Glasfaser-Flugzeug-Service GmbH Hansjörg Streifeneder Hofener Weg 72582 Grabenstetten	Technical Note No. 205-22 No. 206-21	Page: 01/ 02 F.R.G. Type Certificate No. 304
Subject:	Rudder gimbal drive -rear actuator arm-	
Affected:	Sailplane model „Club Libelle“ F.R.G. Type Certificate No. 304 Sailplane model „Hornet“ F.R.G. Type Certificate No. 304 Sailplane model „Hornet C“ F.R.G. Type Certificate No. 304	
Urgency:	The actuator arm must be replaced not later than March 31 st ,2003	
Reason:	Failure of the actuator arm caused by loads applied when regularly lifting the fuselage by ist rudder and/or when fuselage has broken.	
Actions:	<p>The faulty part, made according to drawing No. 203-45-10, must be replaced by an improved actuator arm, made in accordance with drawing No. 203-45-10-2</p> <p>Working instructions:</p> <ol style="list-style-type: none"> 1. Remove rudder by removing the M4 bolt securing the actuator arm to the rudder (located in a cavity at the lower end) 2. Remove horizontal axle from gimbal drive by removing the castellated nut. 3. Remove both castellated nuts from rudder actuator arm and pull mounting bolts inward and off. 4. Attach new actuator arm to gimbal drive by

203-45-10-2

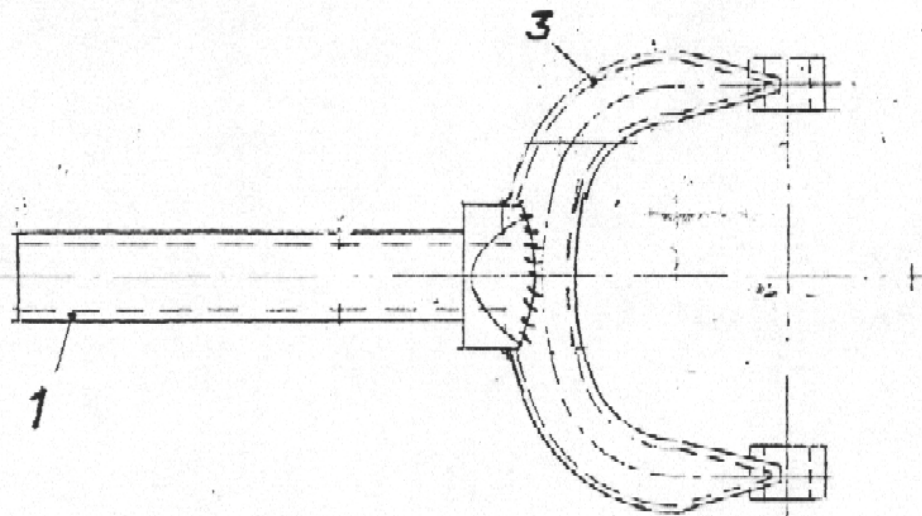
- 1 off rudder actuator arm made according to drawing 203-45-10-2
- 1 off M4 stop nut
- 3 off Split pins, 1.5 x 16 mm

Replacing the actuator arm must be done by Hansjörg Streifeneder Glasfaser-Flugzeug-Service GmbH only or by an approved repair station.
Only genuine parts made in accordance with drawing No. 203-45-10-2 must be used.
Proper accomplishment of the action must be entered into the "sailplane" log book by a licensed inspector.

Im WIG-Verfahren mit Zusatzwerkstoff 1.7734.2 geschweißt. Grundiert mit Wash-Primer 42002 + Härter 40018. Decklackierung mit Nitro-Lack schwarz 18002.

Spannungsfrei gegläht
bei 580°C 4 std.
unter Schutzgas
